**From:** Brad Burns <bburns@chamberlinarchitects.com>  
**Sent:** Wednesday, October 14, 2015 12:40 PM  
**To:** Hanzel Sarah  
**Cc:** Brad Hoag; Paul J. Bradsky  
**Subject:** Alex Johnson window mullion widths  
**Attachments:** Window mullion widths.pdf

ALEX JOHNSON WINDOW REPLACEMENT

NEW WINDOW 'A' & 'B'  
MULLION WIDTH

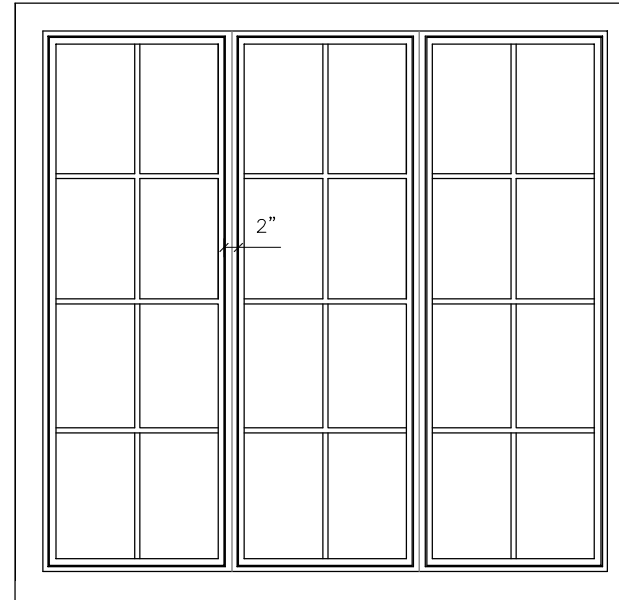
As we discussed, I looked at the mullion width between the original double hung windows. It is 6" wide. Brad Hoag determined that we can get spacers in different increments, so we chose a 4" spacer. That gets us to about a 5-3/4" total mullion width.

Currently, the triple windows would still be directly mulled together making the mullions about 2" wide, which I think looks good proportionally.
